RFI RESPONSE

REG. REF. LRD22A/0930

Dalguise House, Monkstown, Dublin 16, Dún Laoghaire Rathdown

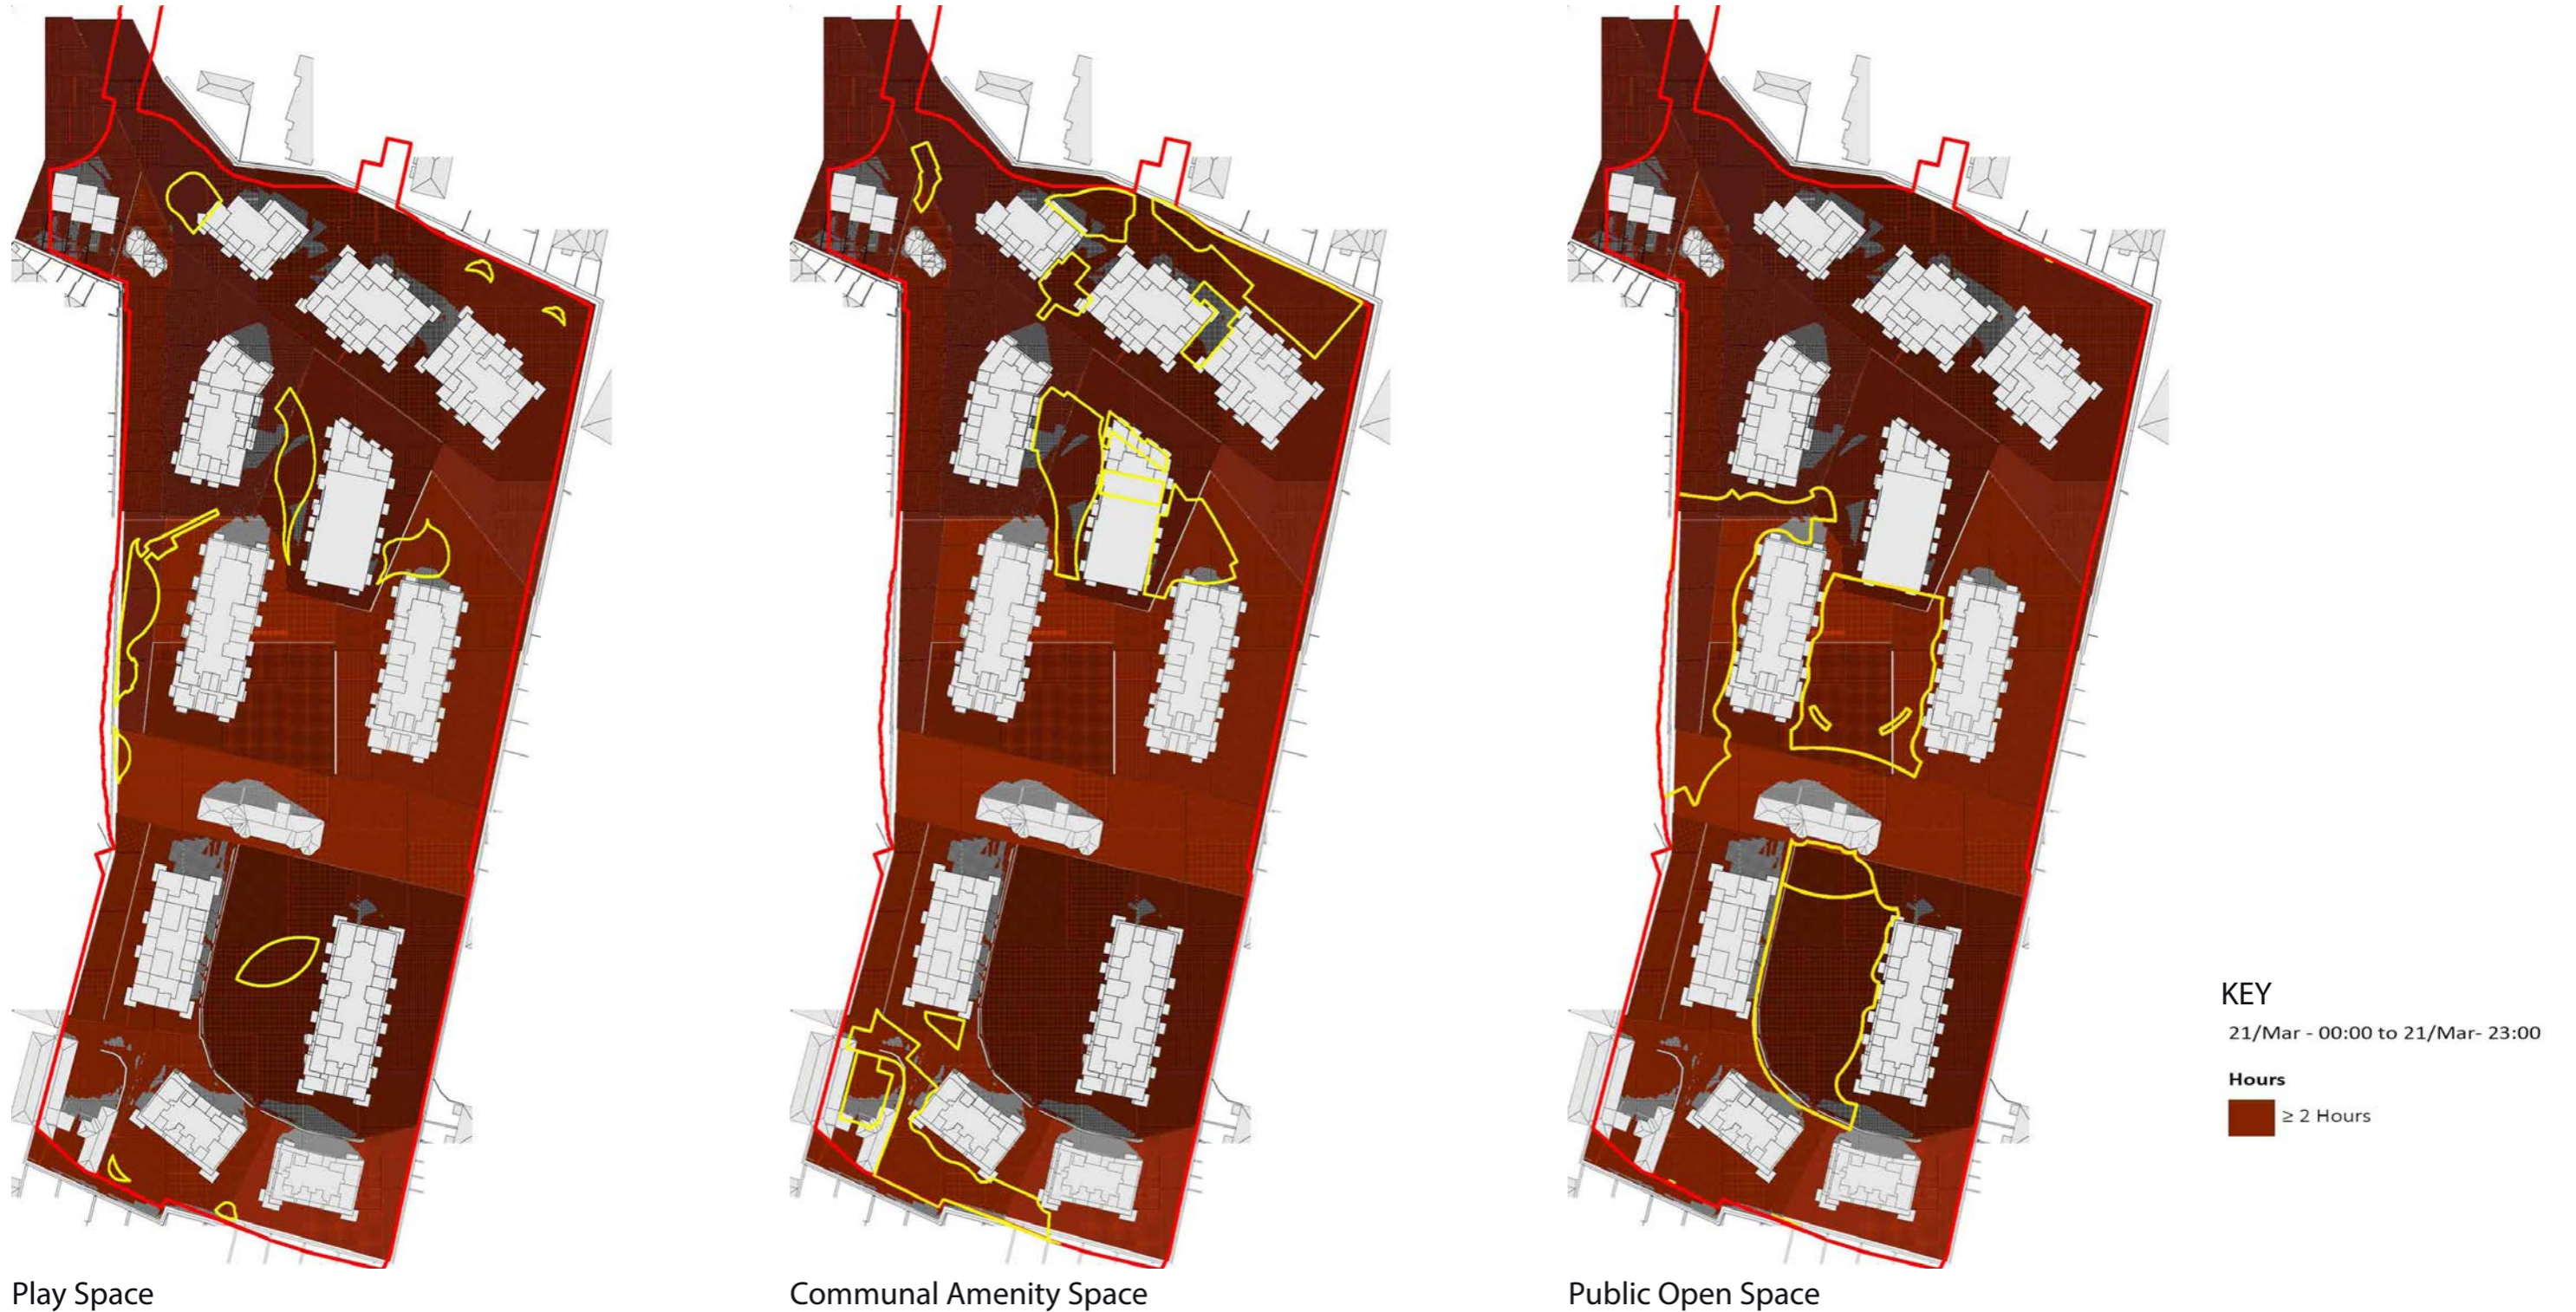
“Concerns arise in respect to the usability and functionality of these communal amenity space and public open spaces without radial sunshine. ...”

Please see below where the outlines of each area have been overlaid onto the sunlight assessment. Any area highlighted in red receives 2 or more hours of sunlight on March 21st.

All amenity spaces pass the BRE Guidelines, with “23 of the 23 assessed areas are in line with the BRE guidelines and achieve excellent levels of sunlight”. The guideline states that for an amenity space to appear adequately sunlit throughout the year, at least half of the amenity space should receive at least two hours of sunlight on the design day, March 21st.”

Public Open Spaces- Tree Walk

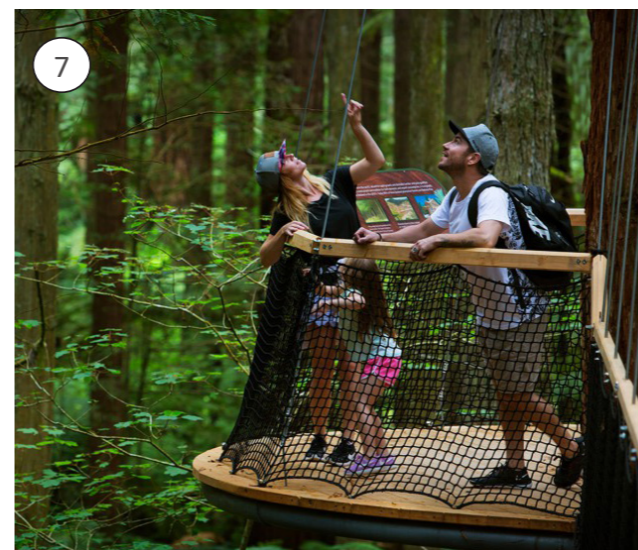
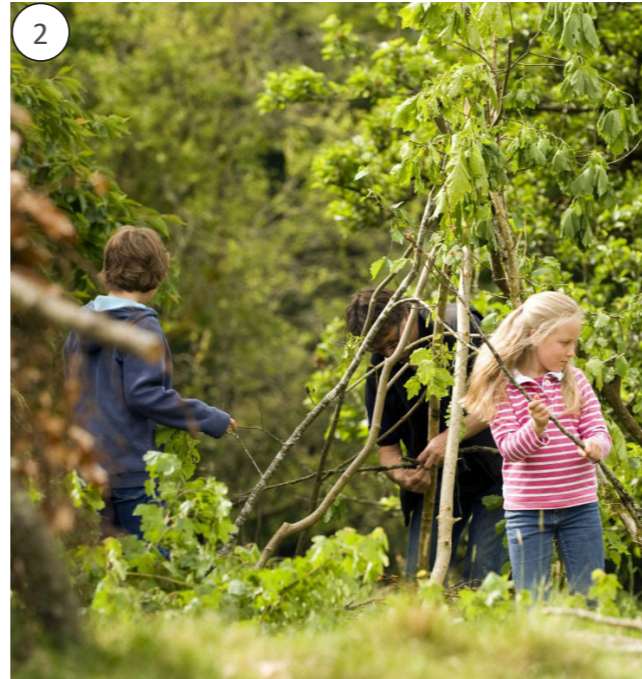
“..The Applicant is requested to submit a design rationale to the usability and functionality of these spaces having regard to the design modifications requested previously.”

The Tree Walk area sits on the west periphery of the site within the existing woodland and connects with other more central spaces. This area features a resin bound path occasionally widened into natural play nodes, featuring seating and nature Play Units. Occasional glades would be managed to allow for greater biodiversity and interest and there would be areas of deadwood/ecopoles that would also act as natural sculpture. The non paved areas of woodland floor are visual and biodiversity amenity while also providing opportunities for creative play with natural found materials.

The main feature would be an elevated tree walkway that allows residents and visitors to get closer to the existing tree canopy and feel at one with nature. Below the walkway an elevated play net, connected to the trees will enable play with nature in a way that has the least impact on root protection zones.

Public Open Spaces- Central Lawn

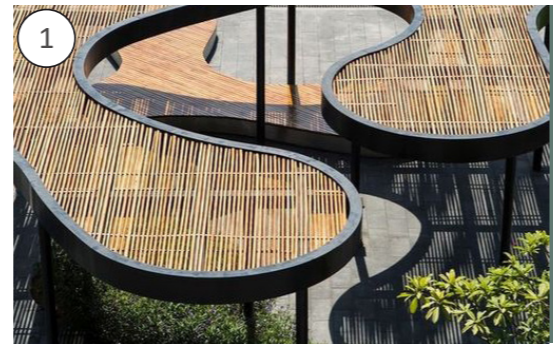
"..The Applicant is requested to submit a design rationale to the usability and functionality of these spaces having regard to the design modifications requested previously."

The central lawn area is the primary public space between Blocks F & G and Dalguise House.

It consists of a large central lawn which is mown short in the middle, with expanses of longer wildflower areas to the sides and landscape mounds with medium sized trees planted on top. These mounds and trees enclose the space and define views towards the house, while providing features outside the residential entrances. A feature tree that is representative of formal parkland landscapes will be planted as a focal tree. People can relax on the benches or lawn and children can enjoy the incidental play provided through the landscape.

A large, south facing, social area is situated to the south of Block E, this will be partly covered to allow for all weather use. The pavilion structure will have a steel frame with timber slats and be organically shaped to work with the organic curves of the landscape. There will also be outdoor chairs and tables to provide the public and community a place to meet with uninterrupted views of the house.

Public Open Spaces- Walled Garden

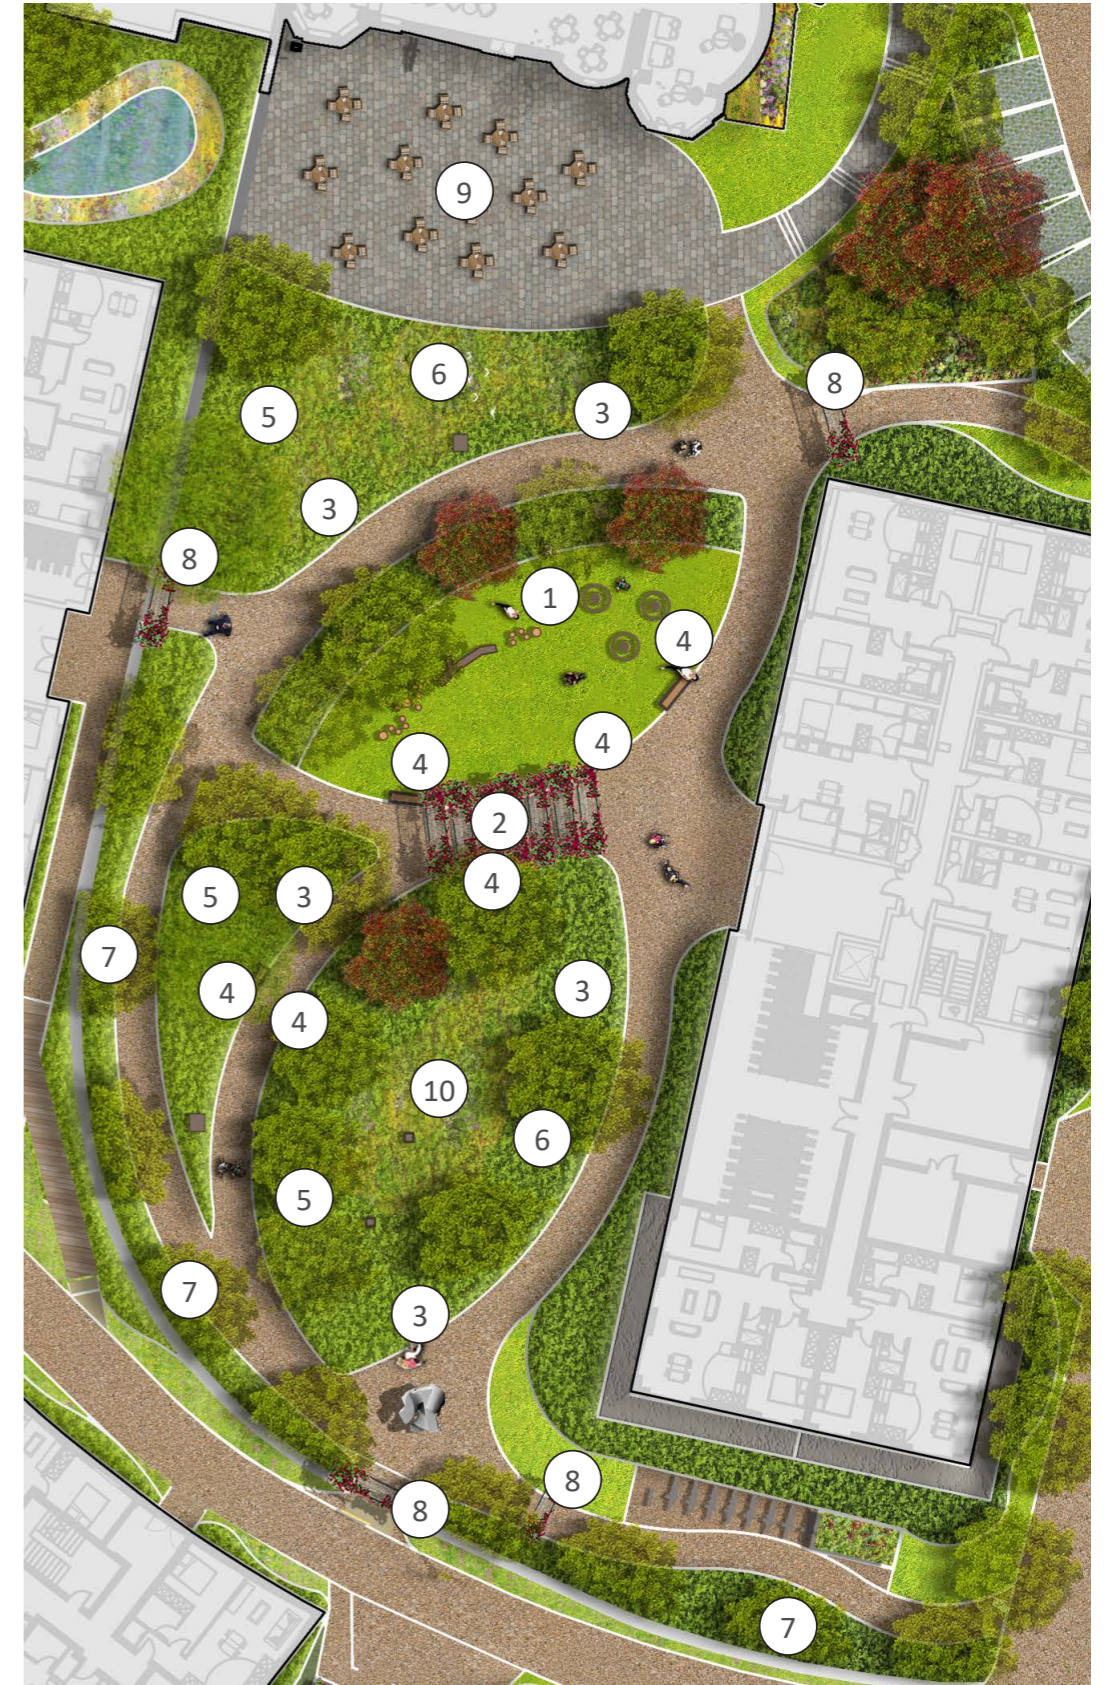
"..The Applicant is requested to submit a design rationale to the usability and functionality of these spaces having regard to the design modifications requested previously."

The space immediately to the south of Dalguise House will be used as a spill-out area for outdoor seating/dining with views of the walled garden.

The walled garden beyond will be split into a more active area with play to the north and a quiet, reflective space to the south, where people can grow and pick edible plants and rest in this sheltered spot. Plant beds will contain mainly edible plants and trees, including herbs, fruits, nuts and vegetables, but also plants of botanical interest. An edible forest approach will be used with the trees planted in an orchard style. The walled garden wall will be retained and lengthened towards the House.

Access into the walled garden will be at points where there is already a break in the wall. Entrances into the walled garden will be signalled with archways with climbers trained along them, framing views and creating a 'secret garden' effect.

The two existing trees of value will be retained within the design. There will be interesting structures within the garden - such as a long pergola trained with fruit trees.

Communal Amenity Spaces- Woodlands

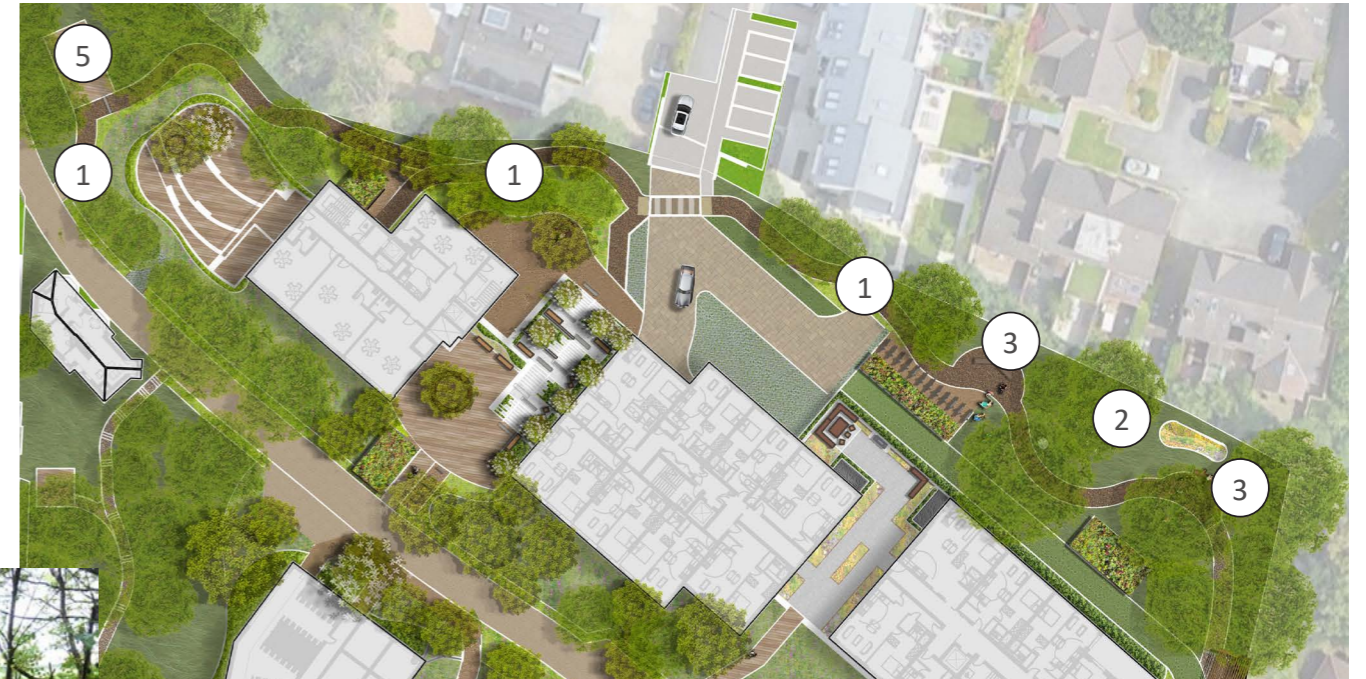
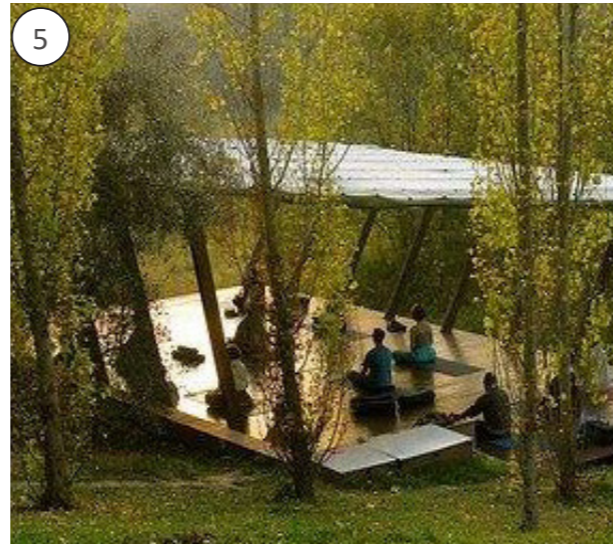
"..The Applicant is requested to submit a design rationale to the usability and functionality of these spaces having regard to the design modifications requested previously."

The woodland walk areas tracks around the northern and southern periphery of the site within the existing woodland and connects with other more central paths, as well as the Public open space Tree Walk. These paths create a walking loop around the site, while providing quiet nooks for residents to gather away from the more active Tree walk. The trail would occasionally widen and natural play nodes would be created. No-dig, sinuous bark resin bound paths wind between existing trees giving access to each seating nook or play node. Where steps must be provided short sections of bark mulch paths are used. This approach ensures all spaces are accessible while having least impact in root protection zones.

The primary feature of this space is a Yoga Platform, nestled amongst the existing trees, this timber decking creates a space for meditation, exercise or imaginative play.

Communal Amenity Spaces- Terraces

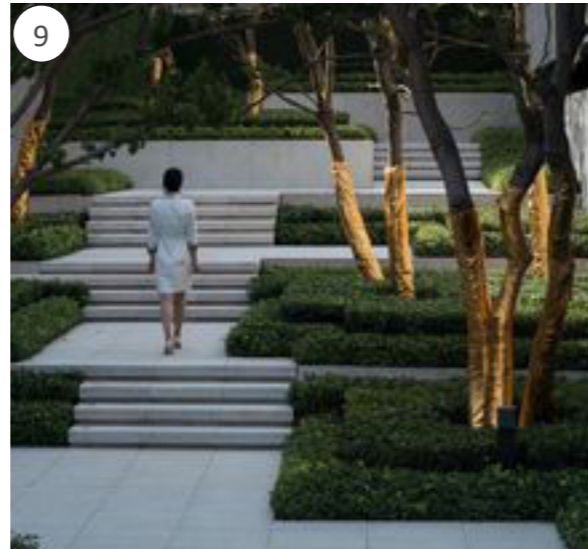
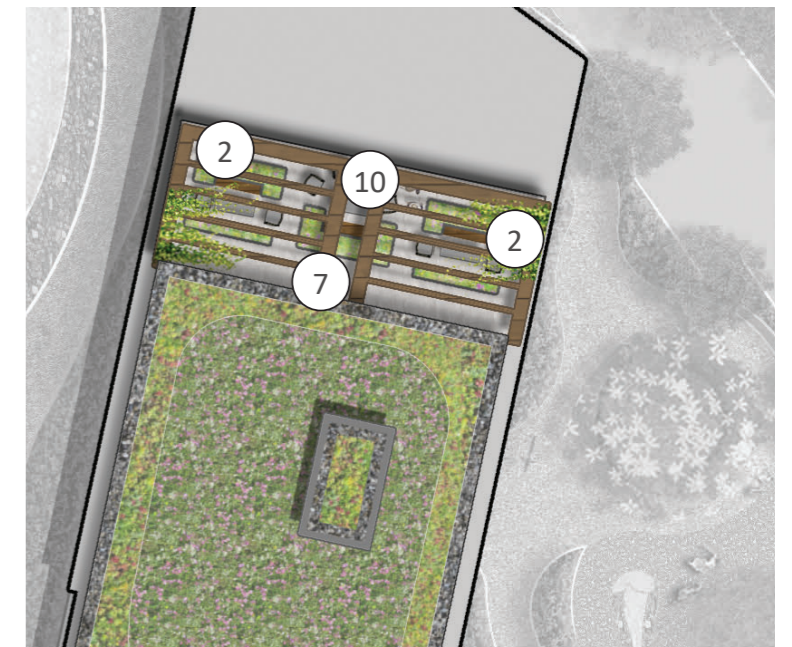
"..The Applicant is requested to submit a design rationale to the usability and functionality of these spaces having regard to the design modifications requested previously."

The communal terraces are located Between blocks A and B, between Blocks B and C and on the 8th floor roof terrace. These spaces provide an alternative atmosphere to the woodland. High quality Planting, paving and furniture create a refined space, allowing residents to gather together or host friends and family outdoors. Spaces are created for cooking, eating, seating and gathering and tabletop games.
